Classification:  
EL09-050b

Reference:  
ITB10-010b

## 2008 – 2009 G37 COUPE; BATTERY LOW VOLTAGE / NO START

This bulletin has been amended. Several changes have been made. Please discard previous versions.

Figure 1

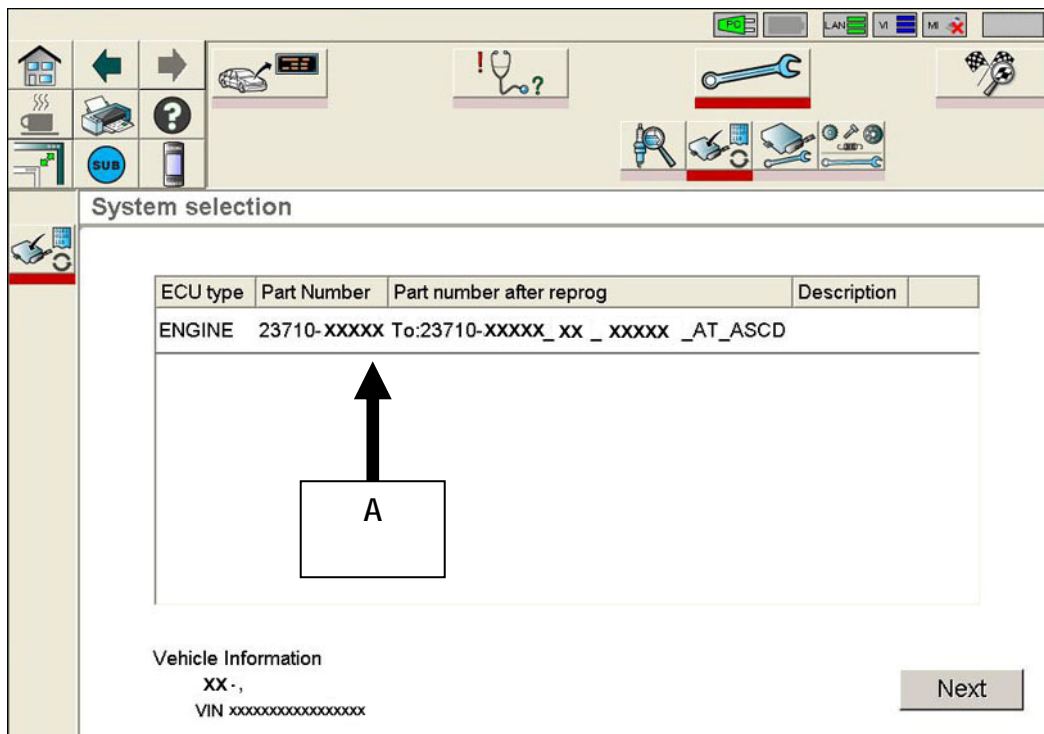
2. When you get to the ECM Reprogramming screen shown in Figure 1, confirm reprogramming is needed as follows:

A. On your C-III screen, look at the Part Number column (see Figure 1)

- If this column is **blank** (no part number listed), proceed to **VENT CONTROL VALVE TYPE CHECK**
- If a Part Number is listed, write it on the Repair Order.

- B. Compare the Part Number you wrote down to the numbers in the **Current ECM Part Number** column in Table A.
- If there is a match, continue with the reprogramming procedure.
  - If there is not a match, proceed to **VENT CONTROL VALVE TYPE CHECK**.
